# WASTEWATER SYSTEM IMPROVEMENTS
# FOR THE
# GRAND STRAND WATER AND SEWER AUTHORITY

PART 1 TRANSMISSION PIPELINES

PROJECT NO. CA68505.71

ADDENDUM # 2 - Supplement for Rebid

SHEET NO. A-5

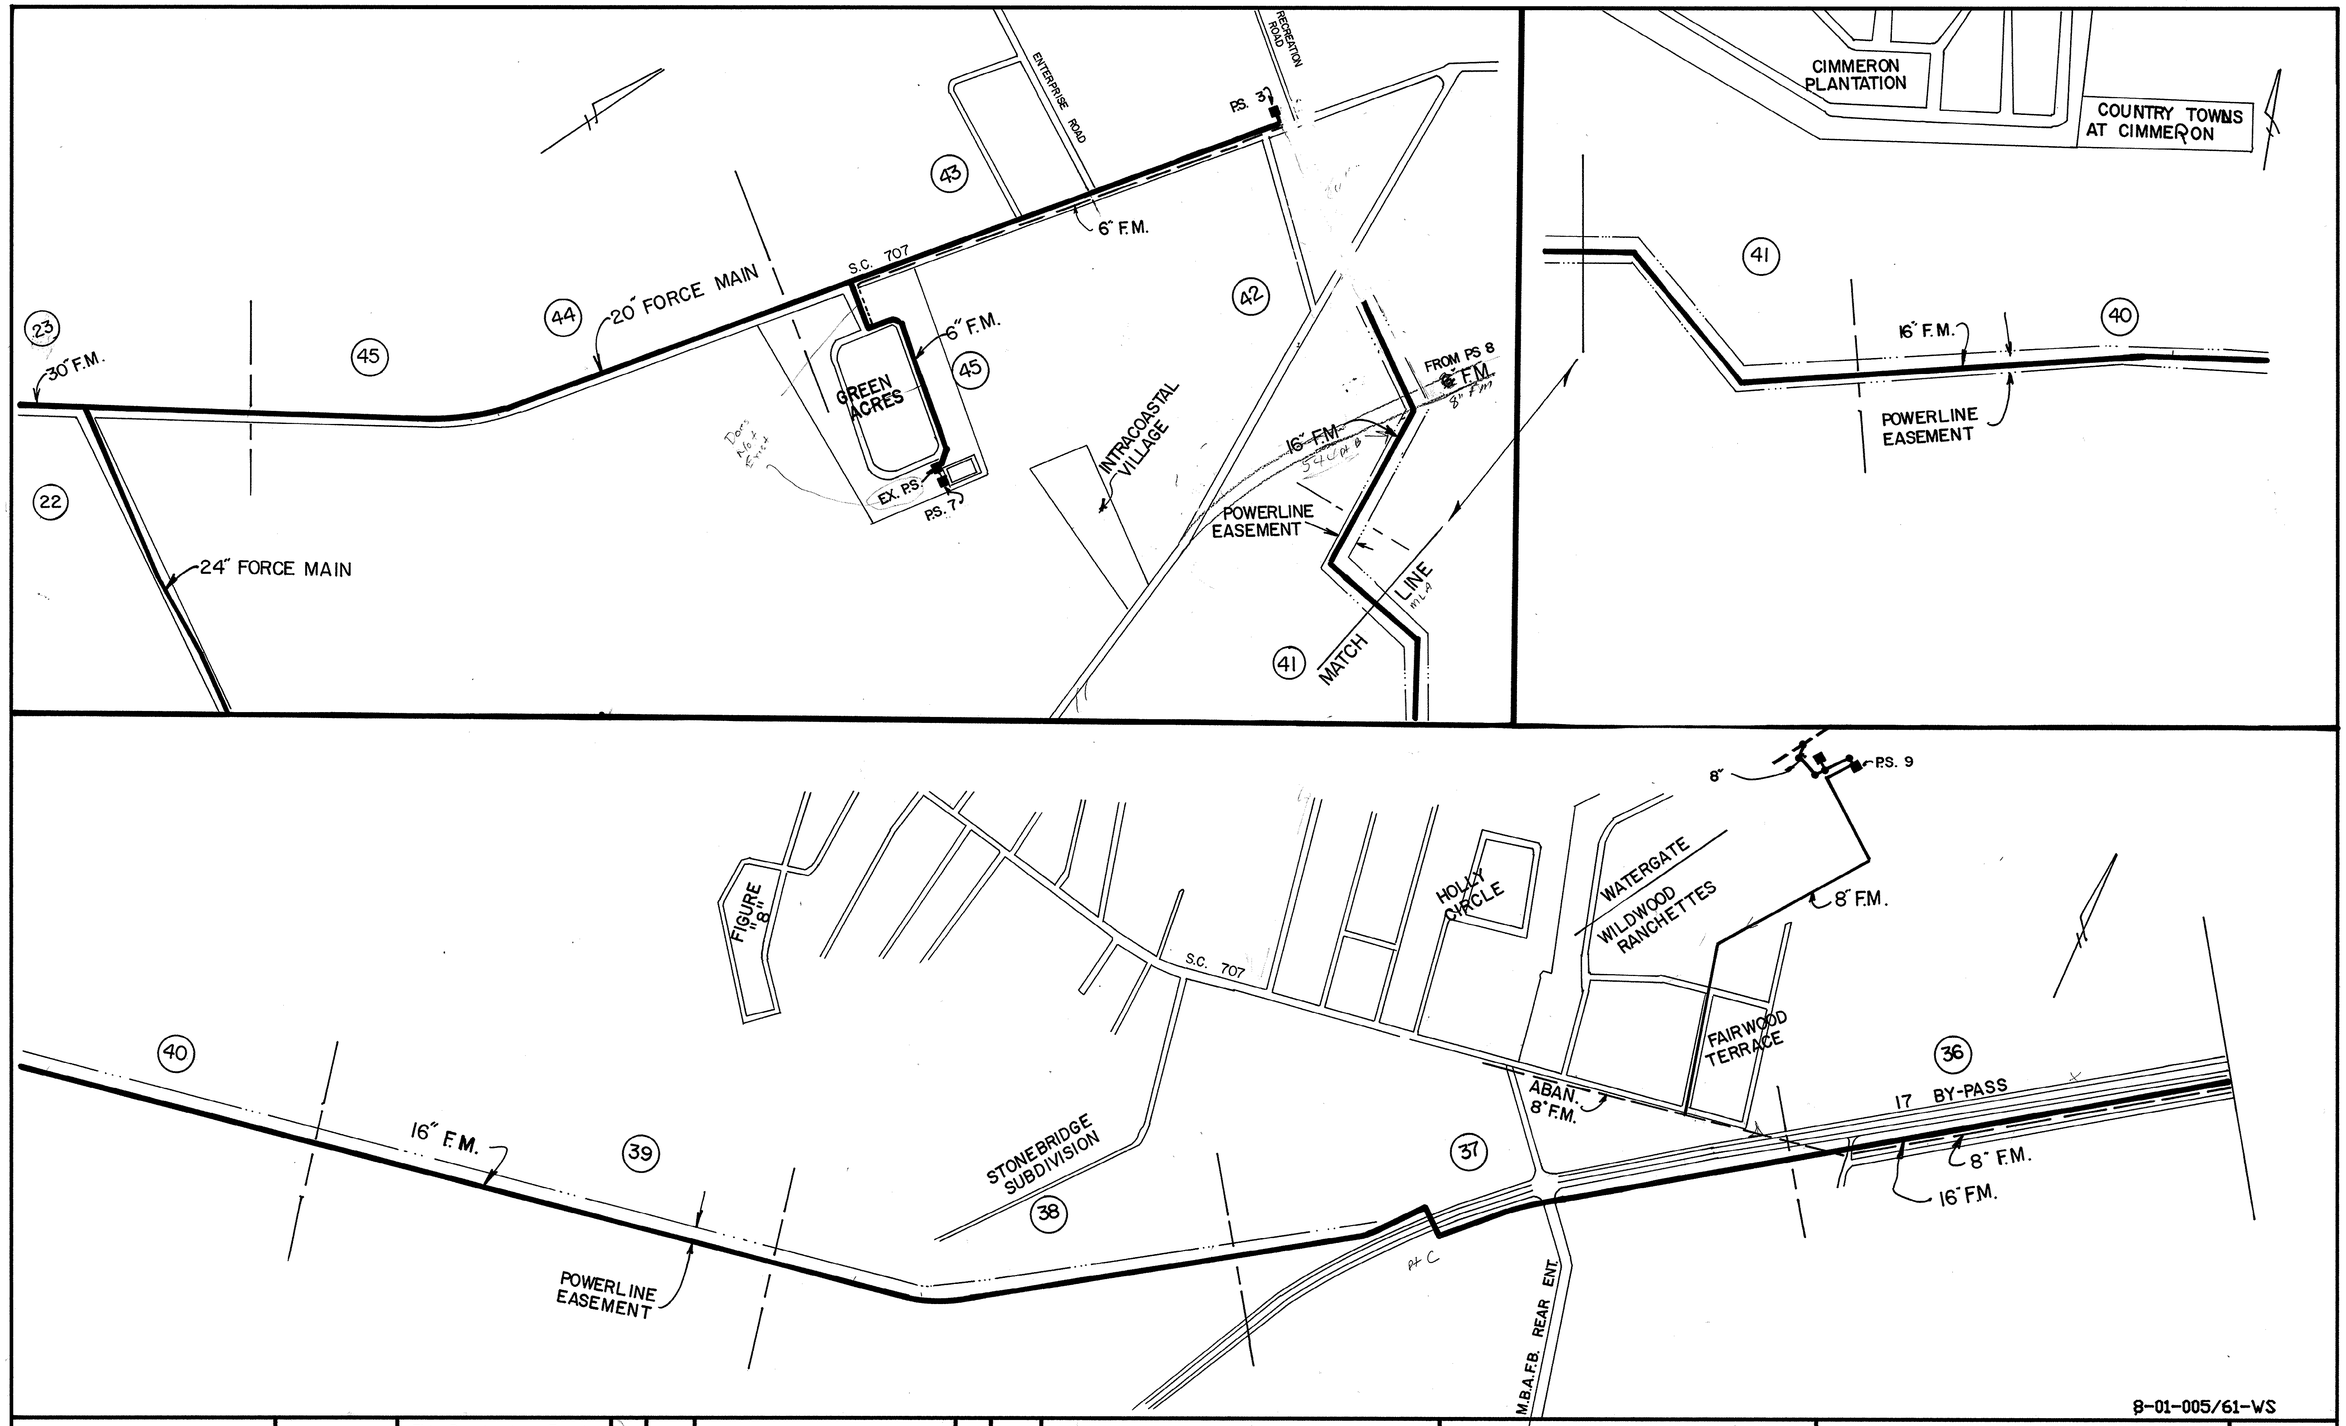
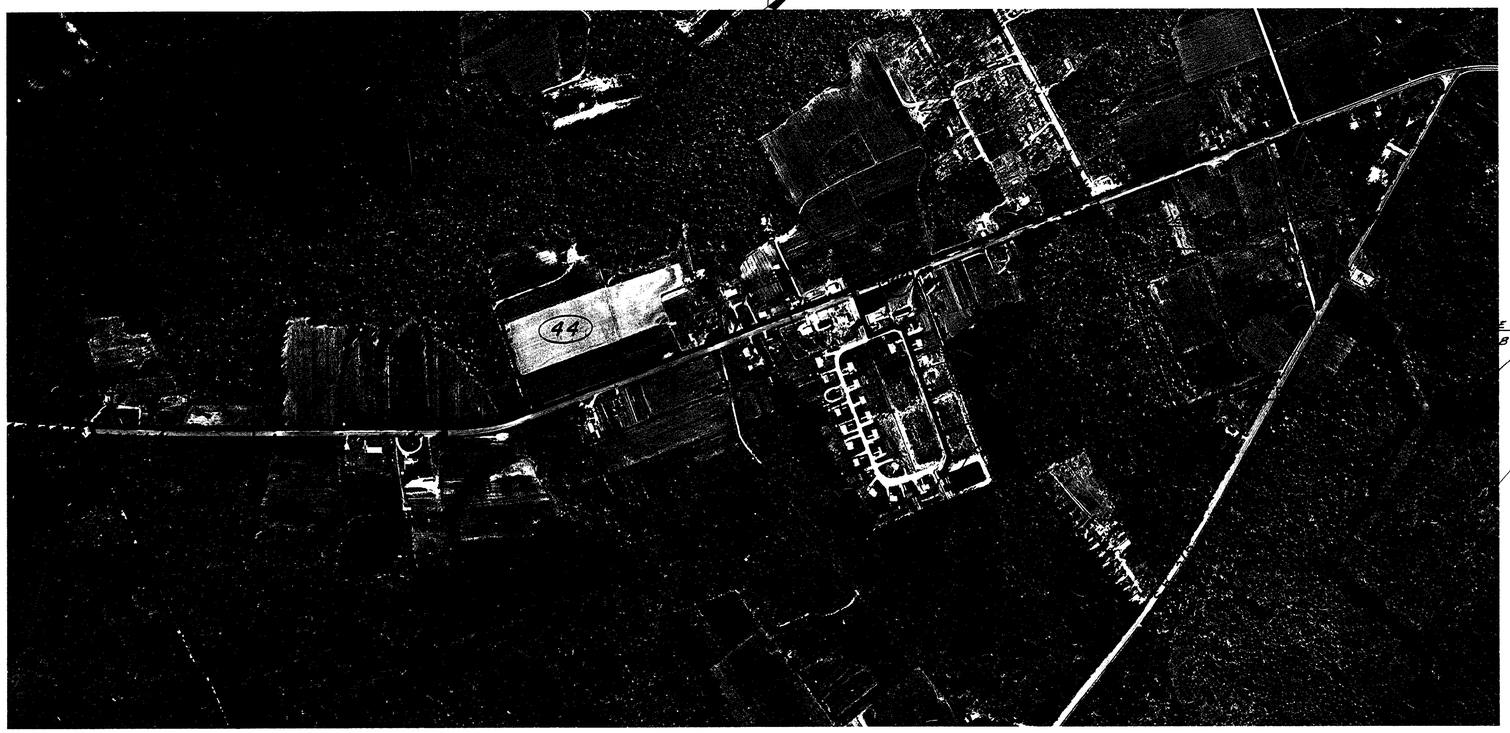
ADD-2 8" F.M. - DELETE NOTE (PART 2)

SHEET NO. A-6

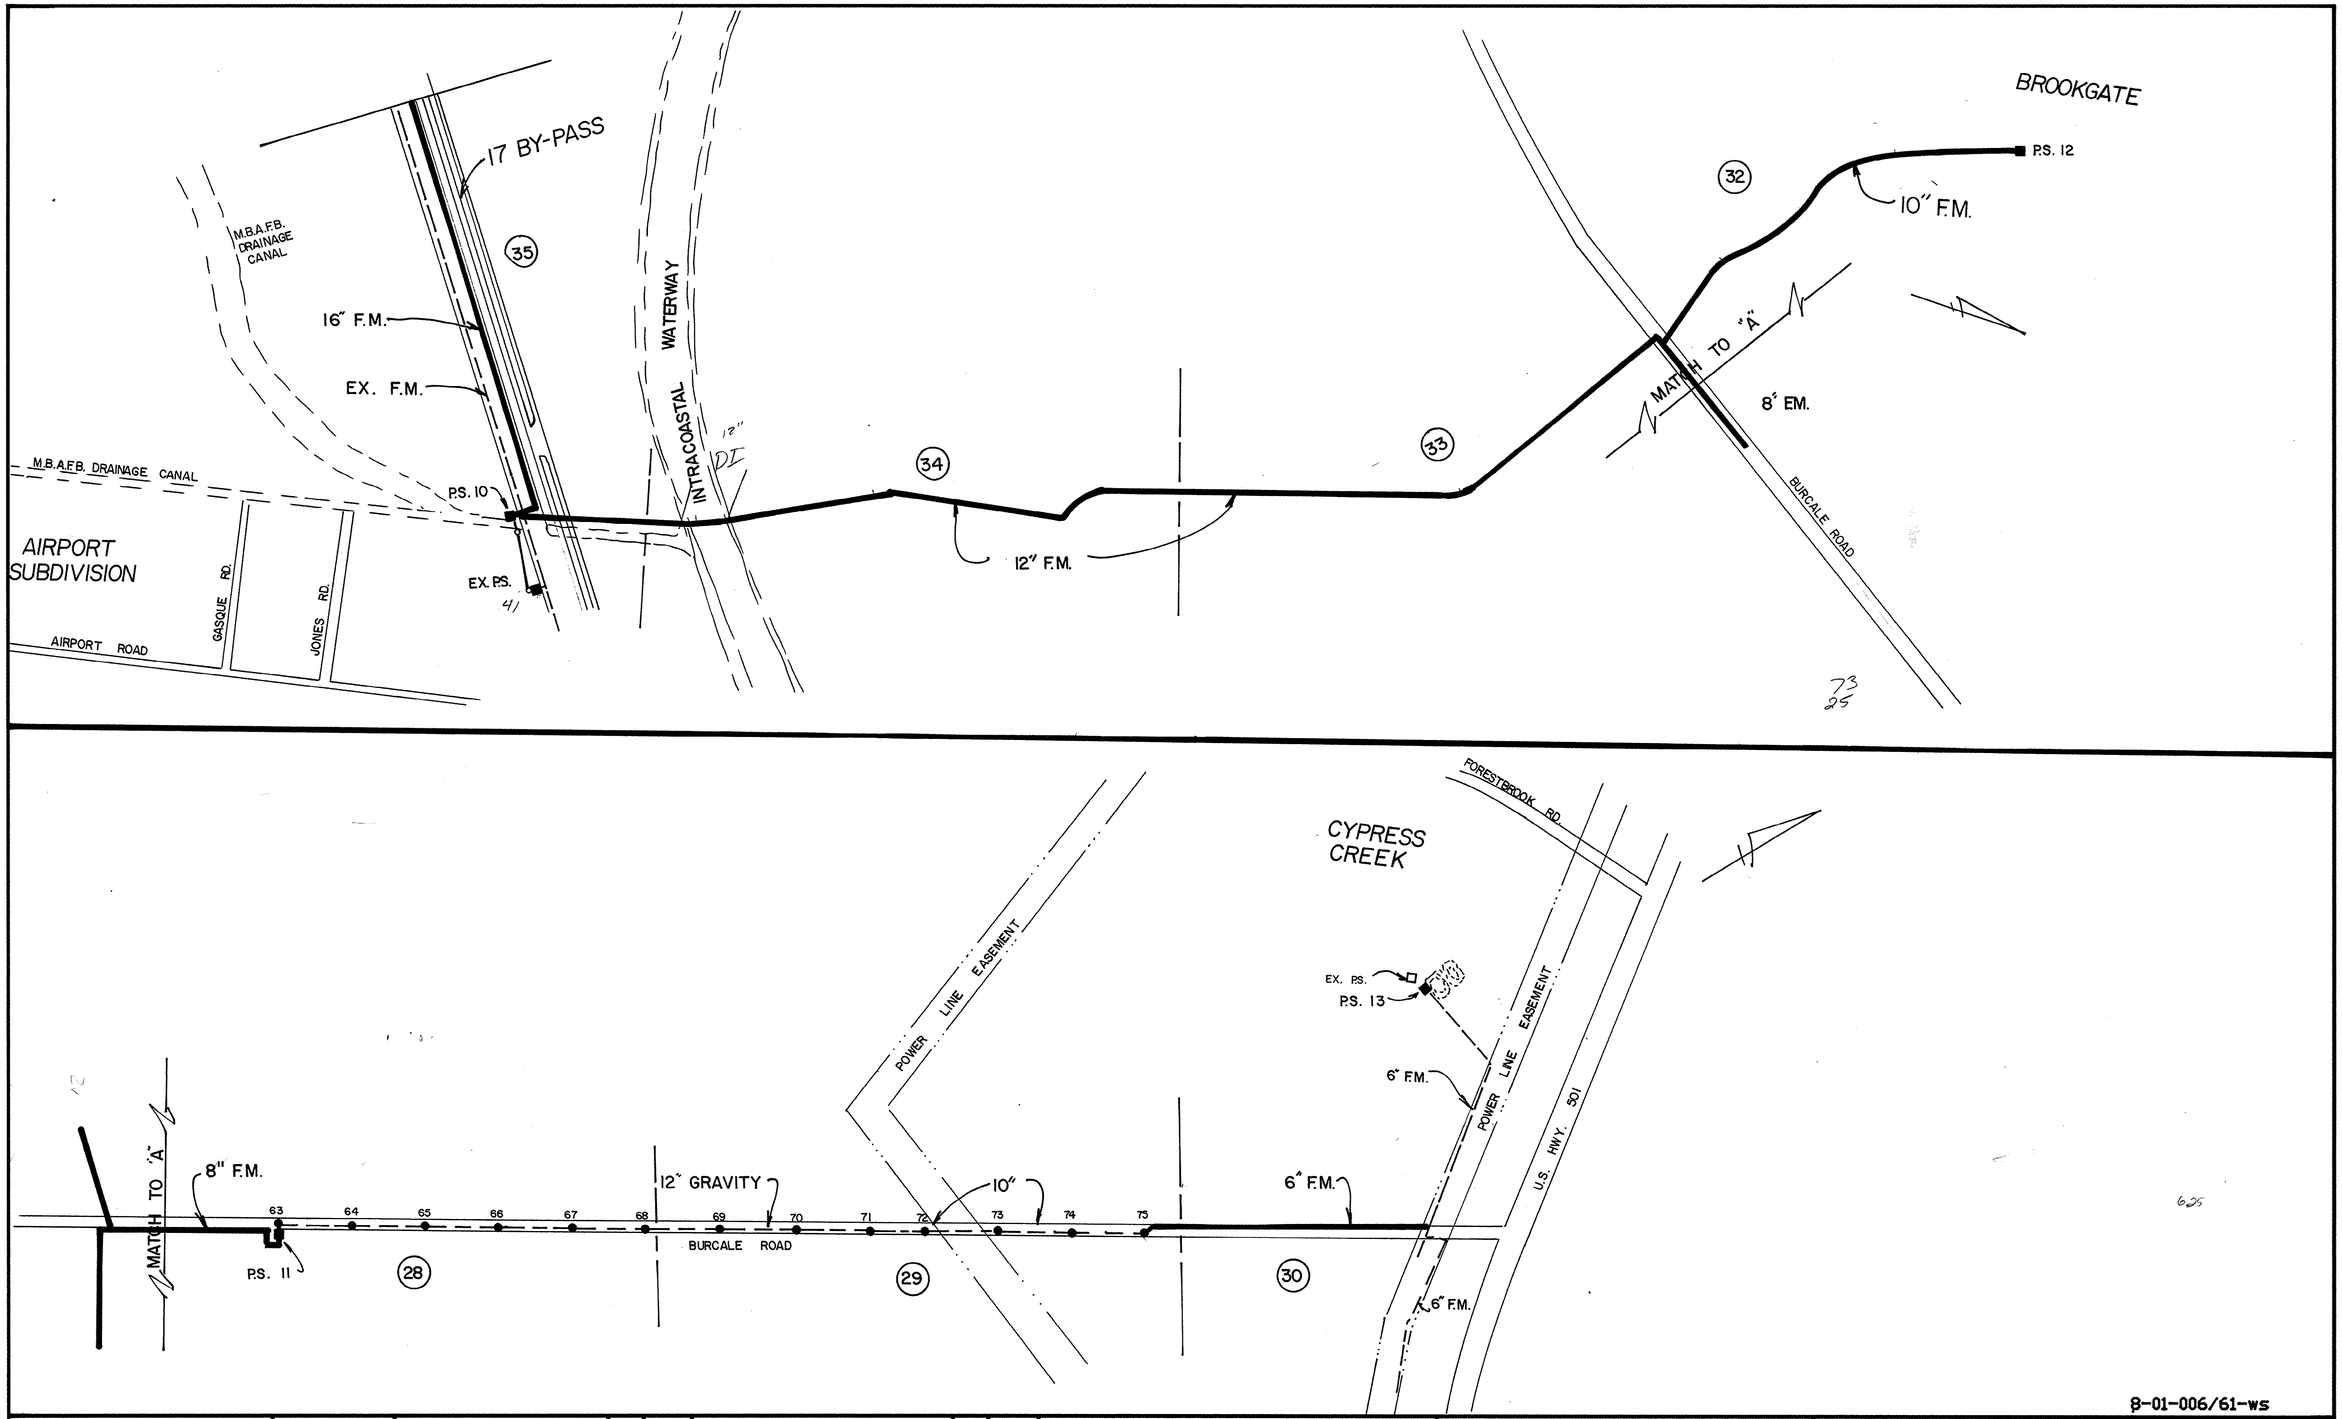
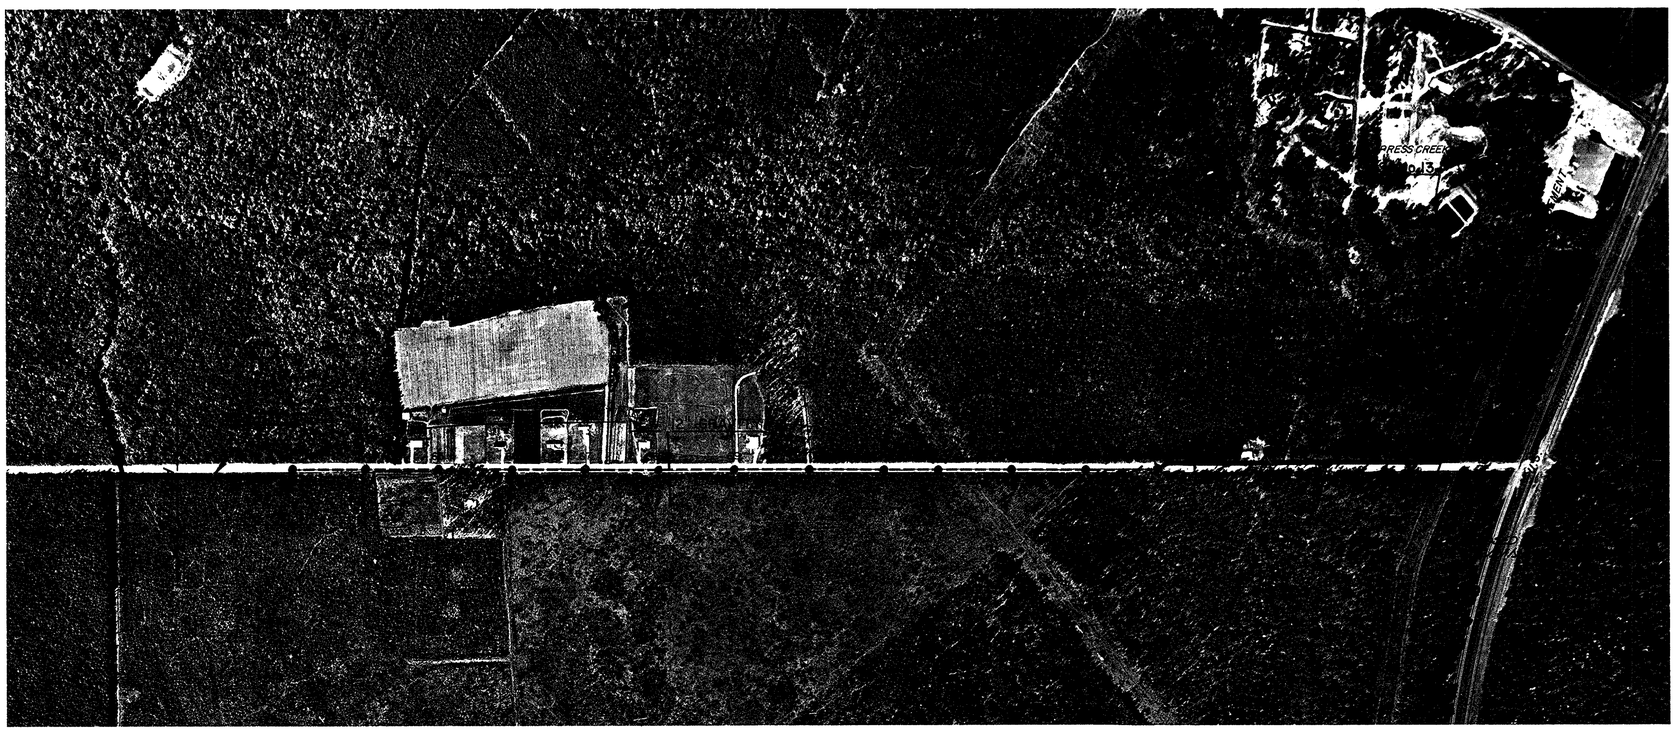
2 400-2 10" F.M.- DELETE REFERENCE (PART 2)

SHEET NO. 3

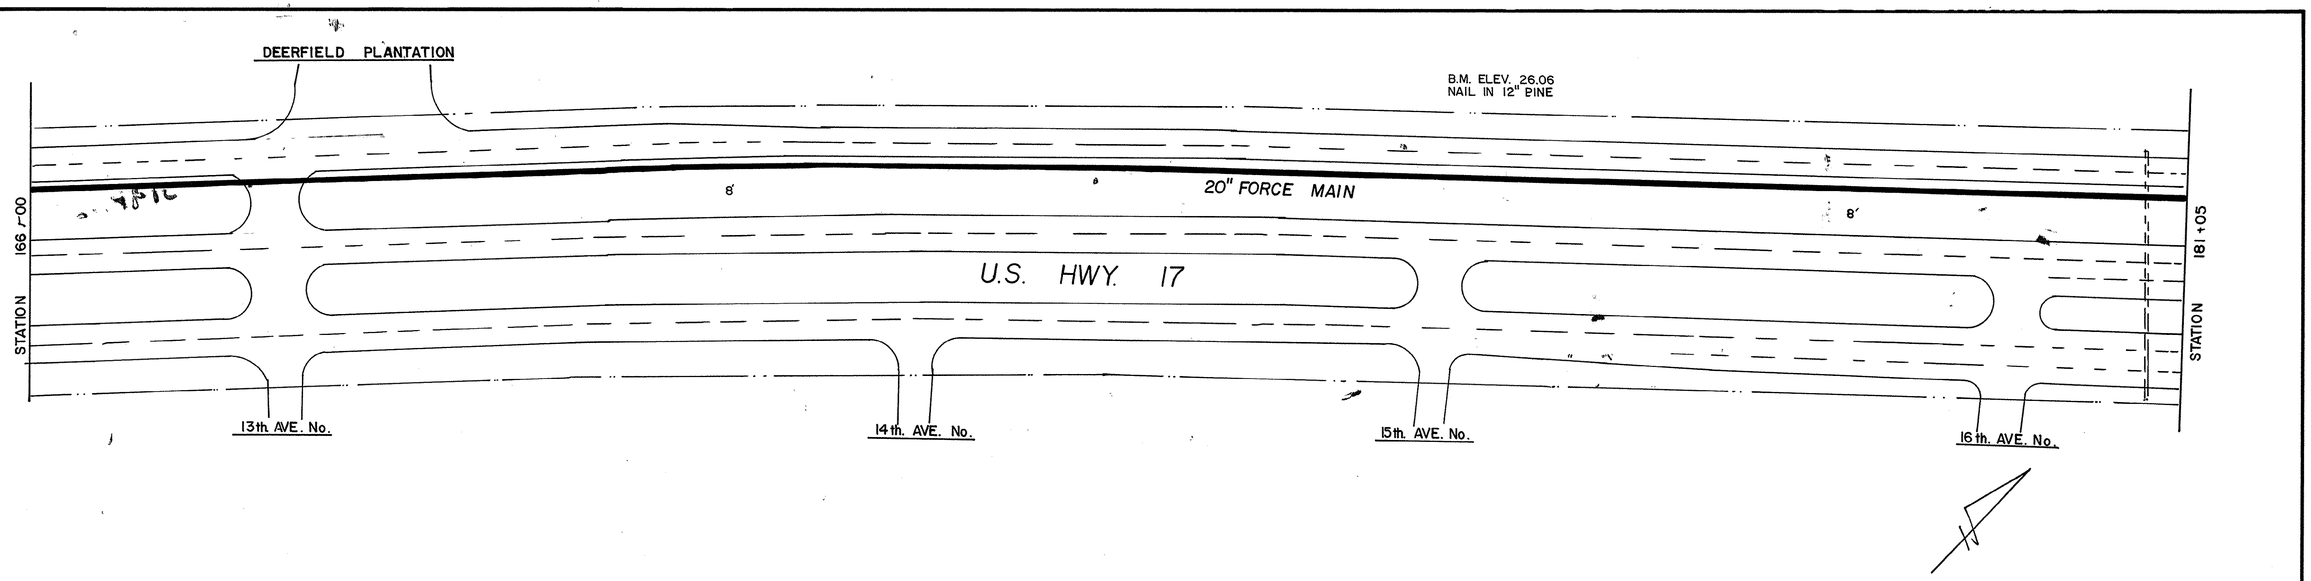
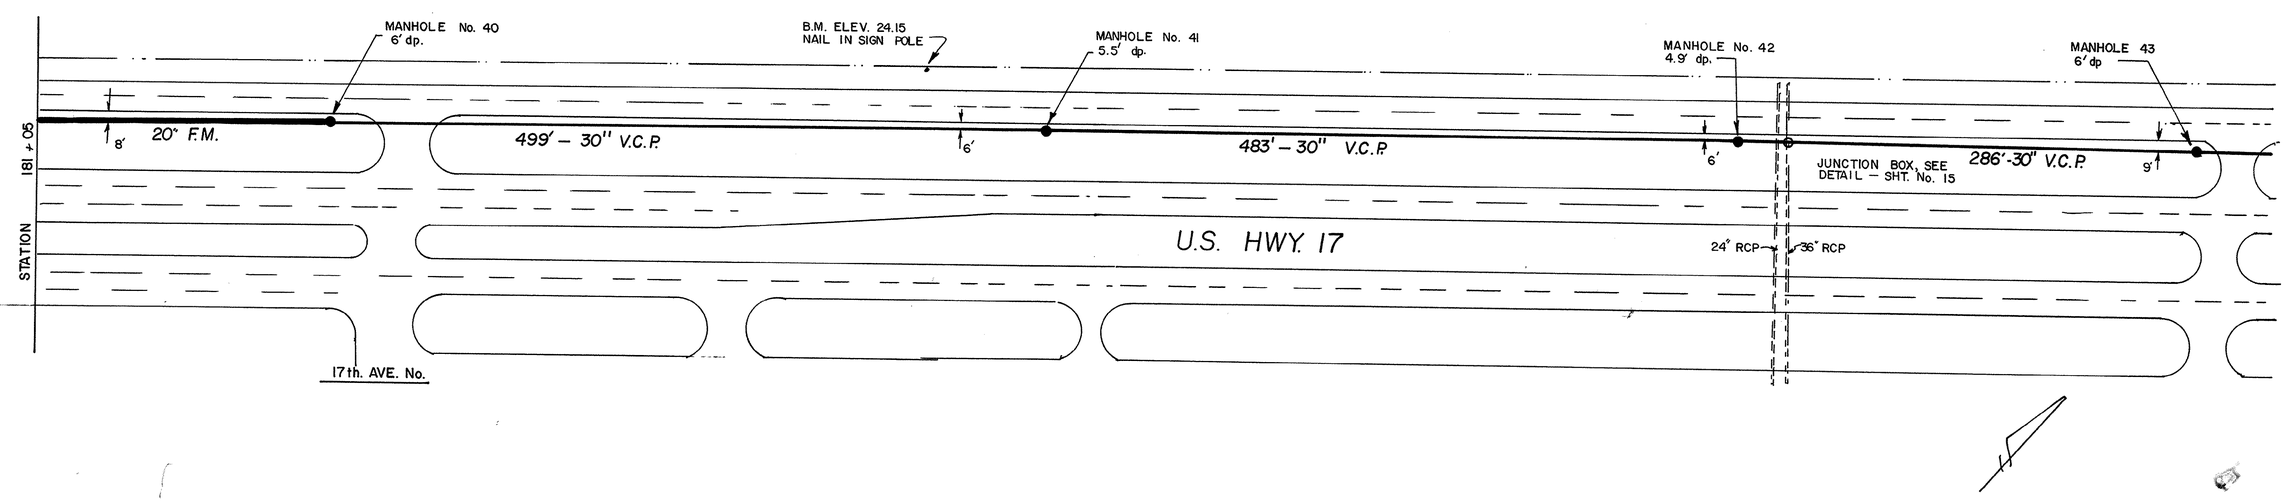
ADD 2 NOTE: CHANGE 21" GRAVITY SEWER TO (JAN. '79) 20" FORCE MAIN
